WLTP-SG-EV-08-06

Mode Selectable Switch

Subgroup EV

2015/04/13

Proposal for the mode selection – alternative solution (flow chart):

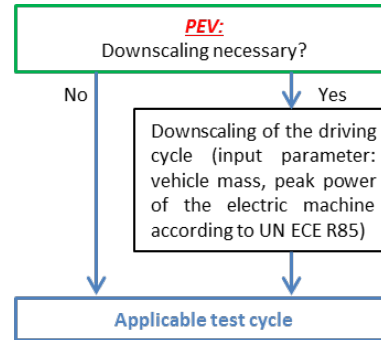
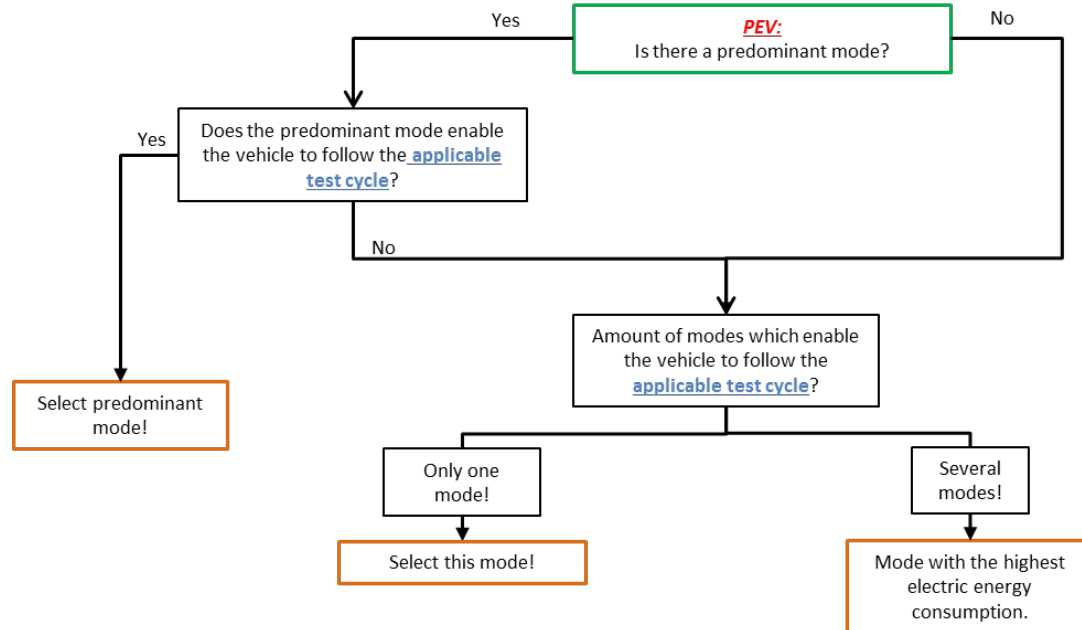
1. Step:

2. Step:

For vehicles equipped with a driver-selectable operating mode:

1. If there is a predominant mode that does enable the vehicle to follow the applicable test cycle (within the speed trace tolerances according to Annex 6, paragraph 1.2.6.6.), this mode shall be selected.
2. If there is no predominant mode or if there is a predominant mode but the predominant mode does not enable the vehicle to follow the applicable test cycle (within the speed trace tolerances according to Annex 6, paragraph 1.2.6.6.), the test shall be performed by using a mode that enables the vehicle to follow the applicable test cycle (within the speed trace tolerances according to Annex 6, paragraph 1.2.6.6.). If this is a single mode, this mode shall be selected. If several modes are capable of following the applicable test cycle (within the speed trace tolerances according to Annex 6, paragraph 1.2.6.6.), the most electric energy consuming mode of those shall be selected.

Current description for the mode selection for the CD type 1 test (Phase 1a amendment):

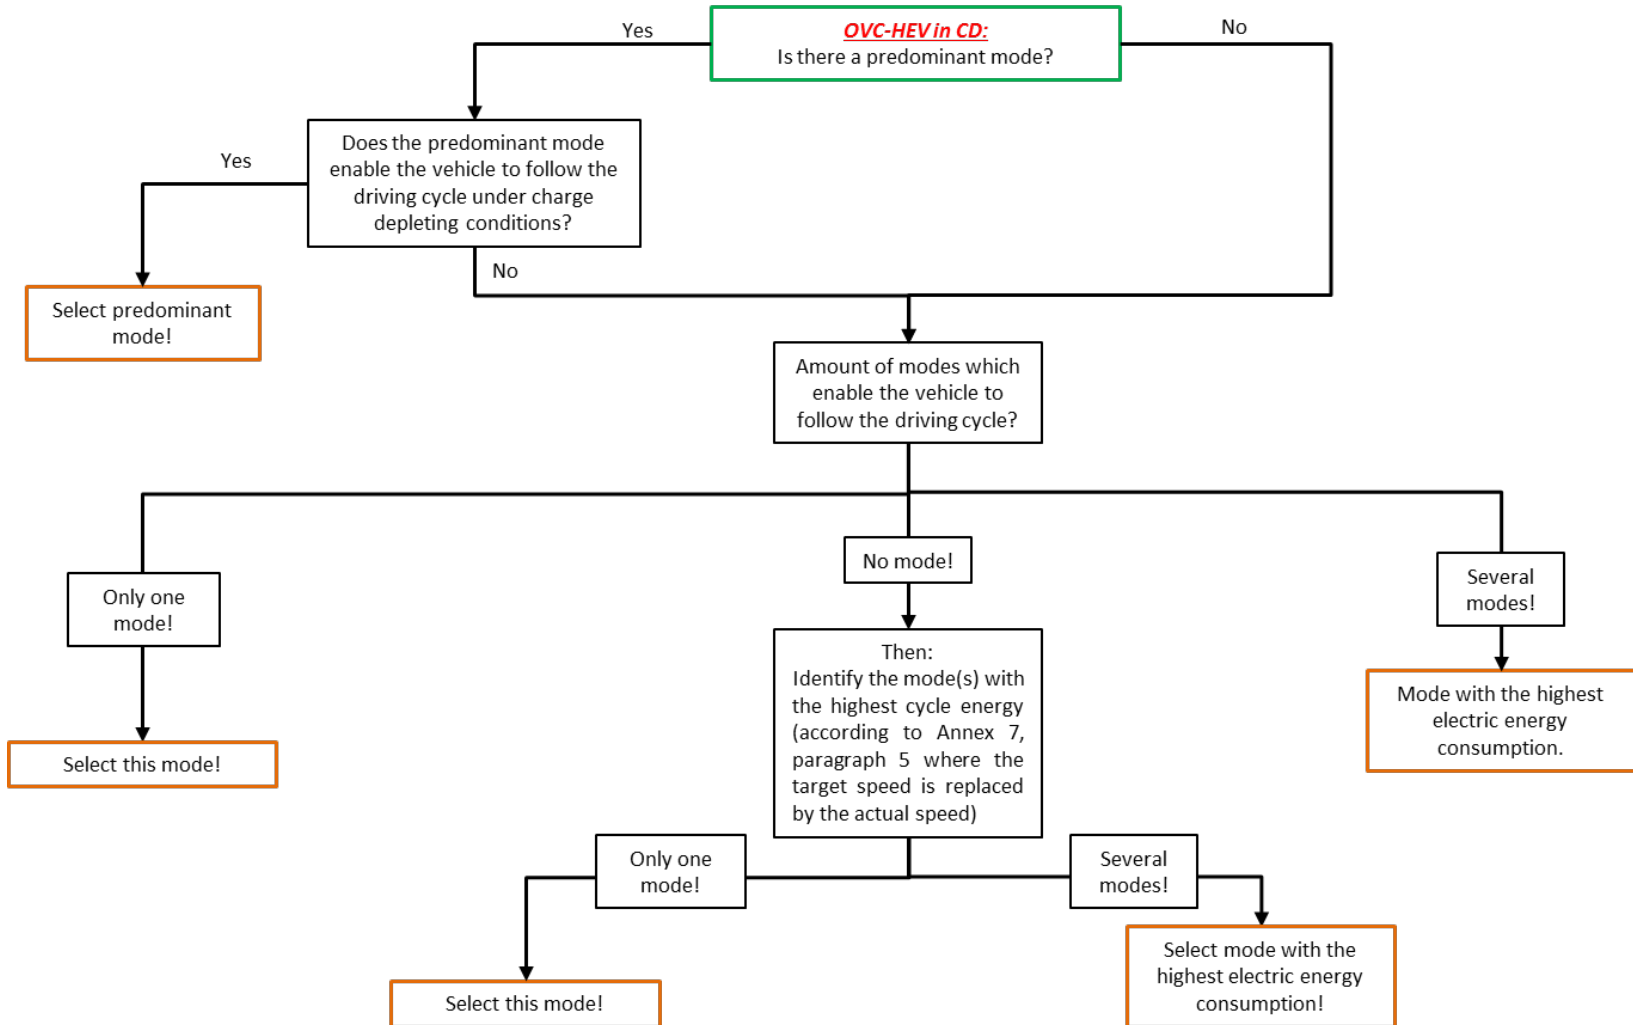
The charge-depleting test shall be performed by using a mode that enables the vehicle to follow the driving cycle (within the speed trace tolerances according to Annex 6, paragraph 1.2.6.6.).

If several modes are capable of following the driving cycle (within the speed trace tolerances according to Annex 6, paragraph 1.2.6.6.), the most electric energy consuming mode of those shall be selected.

Proposal for the mode selection for the CS type 1 test – alternative solution (flow chart):

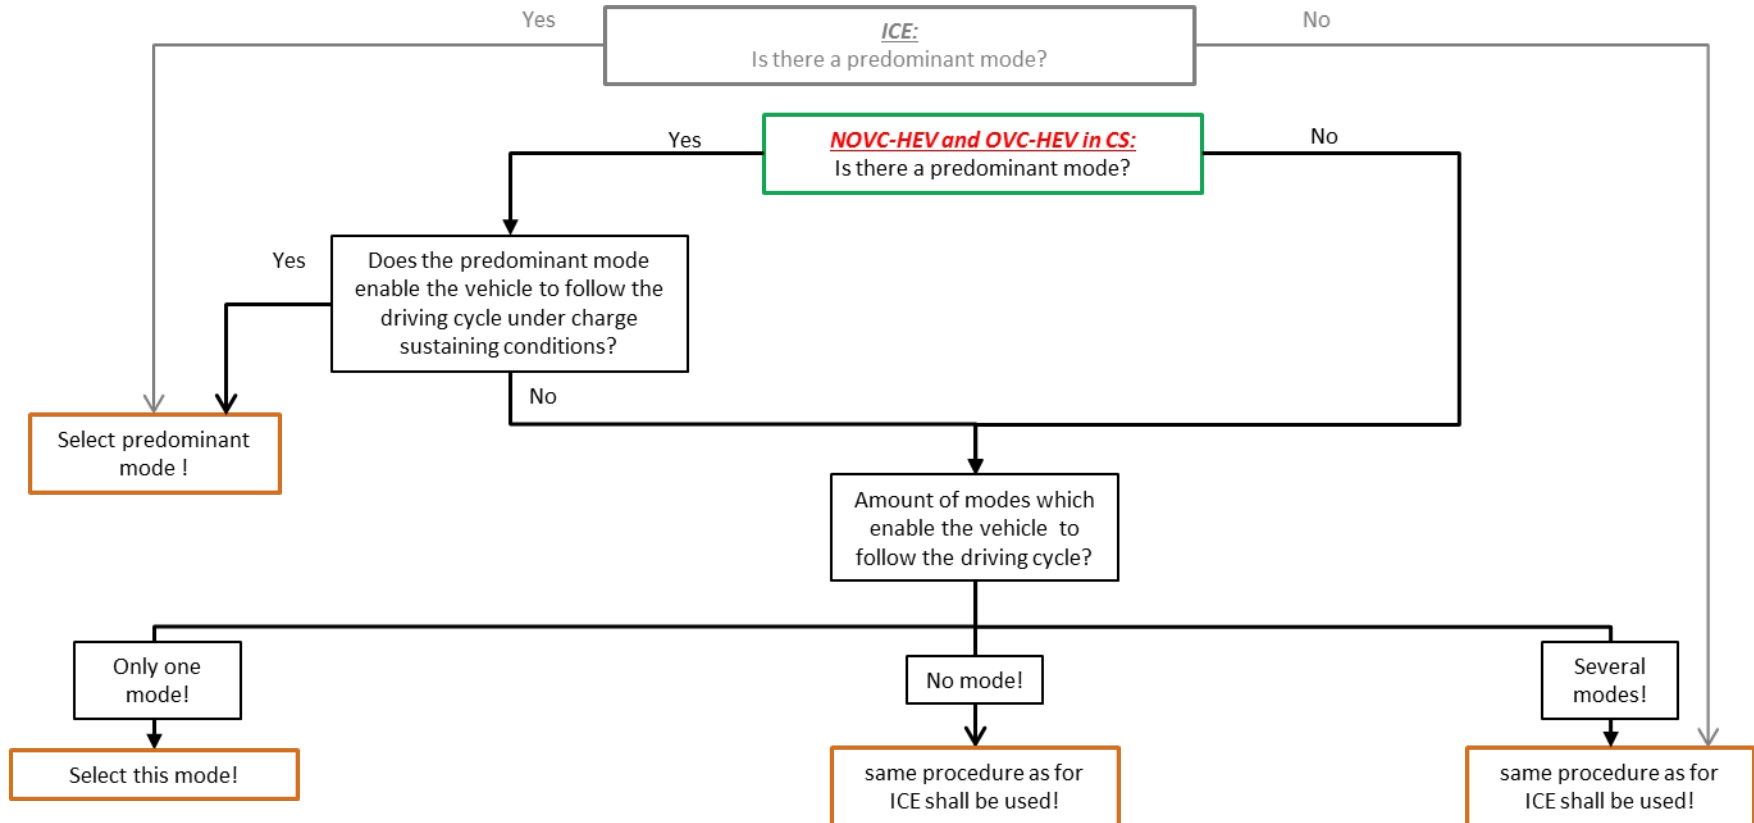
(No system power is available for downscaling and p-tm-ratio)

Due to the non-availability of a system power, there is no downscaling and power to mass ratio applicable
→ Additional requirement for predominant mode in case of NOVC-HEVs and OVC-HEVs under Charge-Sustaining conditions: Following the drive cycle

For vehicles equipped with a driver-selectable operating mode:

1. If there is a predominant mode that does enable the vehicle to follow the driving cycle (within the speed trace tolerances according to Annex 6, paragraph 1.2.6.6.) under charge sustaining conditions, this mode shall be selected.
2. If there is no predominant mode or if there is a predominant mode but the predominant mode does not enable the vehicle to follow the driving cycle (within the speed trace tolerances according to Annex 6, paragraph 1.2.6.6.), the charge-sustaining test shall be performed by using a mode that enables the vehicle to follow the driving cycle (within the speed trace tolerances according to Annex 6, paragraph 1.2.6.6.).
 - a. If this is a single mode, this mode shall be selected
 - b. If there are several modes, same procedure as for ICE shall be used
 - c. If there is no mode, same procedure as for ICE shall be used
